BCC DS
RECEIVED
05/11/2026
APPLICATION REF
A007144800

Change Application (Minor Change)
317 Stafford Road, Stafford
Town Planning Assessment

MEWING
PLANNING
CONSULTANTS

Figure 1: Proposed changes to minimum height clearance (Source: Cottee Parker, 2026)

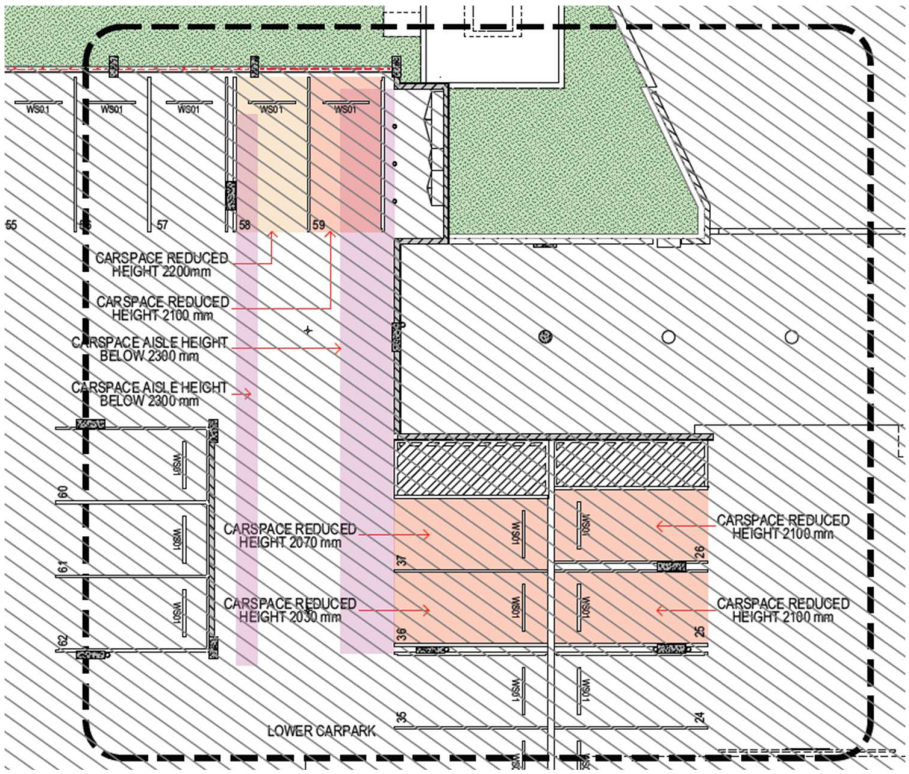
As presented on the Architectural Plans prepared by Cottee Parker included in **Appendix C** to this report, the Applicant proposes to reduce the approved minimum height clearance (in part) within the undercover car parking area. The proposed change specifically relates to seven (7) car parking spaces, identified as car parks 24, 25, 26, 36, 37, 58 and 59 as illustrated in **Figure 1** below. The changes specifically include:

- A local reduction in height above the above stated car parking spaces, achieving heights ranging from 2,030mm to 2,235mm.
- A 2,200mm clearance within one parking aisle which will govern the effective height clearance of that parking module.

Other car parking spaces remain available on the site with a 2,300mm clearance, as approved.

The proposed change is illustrated in **Figure 1** below.

As detailed within the Traffic Assessment (**Appendix D**), the changes to the minimum height clearances do not change the functionality of the car parking bays and remain acceptable from a traffic engineering perspective. It has been recommended that each affected by should have a conspicuous low-clearance sign visible from the approach aisle, together with contrasting delineation of the local overhead restriction.

The east-west cable tray affects the vehicle travel path within one parking module. A flexible height bar is recommended at the module entrance in the indicative location shown, with its underside mounted at 2.2 metres above the finished pavement "Low clearance 2.2 metres'. Refer to Figure 1 of the Traffic Assessment (**Appendix D**) for further detail on the location of the proposed height bar.

This is an acceptable outcome from a traffic engineering standpoint and meets the general headroom requirement of AS/NZS 2890.1, which specifies a general minimum headroom of 2,200mm for cars and light vans. It also requires entrance clearance signs and appropriate warning devices, such as flexible striker bars where the signed clearance is below 2.3 metres. Accordingly, a clear 2,200mm vehicle travel path meets the general headroom requirement of the Australian Standard.
